URGENT – Field Safety Notice (FSN)

Product: Encore, Chorus and Sara Plus Standing Aids
Issue Date: May 14, 2012
Type of action: Warnings / Update to Instructions for Use
Ref: FSN003/2012/PHD

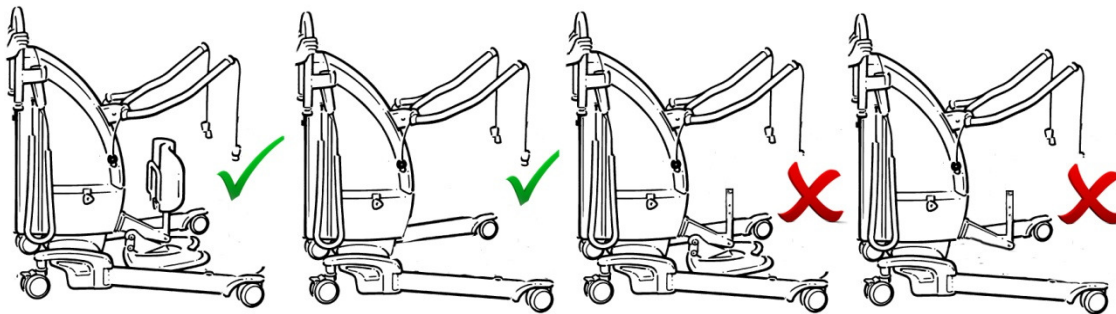
ArjoHuntleigh has recently been made aware of an unfortunate serious accident. During exercise, an Encore Standing and raising aid was used to support the patient to stand. The knee pad had been removed. However the support bracket holding the proactive knee pad support had not been removed as described in the instructions for use manual. This results in a vertical square section end of the metal support bracket becoming exposed.

It would appear that the patient fell onto the metal bracket causing severe trauma. This accident could have been avoided if the support bracket assembly had been removed with the proactive knee pad support.

ArjoHuntleigh would like to remind users that the entire knee pad **and support bracket assembly must** be removed when required to do so for exercise.

The Pro-Active knee pad assembly can be removed to allow exercise. Ensure that when the knee pad is removed, the adjoining support bracket is **always** removed before therapy begins. When refitting, ensure the pad is reinserted, retightened and covers the support bracket.

Failure to do so could lead to serious injury.

- Ensure that the knee pad support bracket is never left on the device without the knee pad being in place to prevent the bracket from being exposed.
- Ensure that this field safety corrective action notice is brought to the attention of all users of these devices.
- Ensure that a copy of this field safety corrective action notice is placed with the instructions for use manuals for the products listed in this notice.
- Ensure that this safety corrective action notice is available to all users.
- Where applicable, include this requirement in the training and refresher training of staff and care givers.
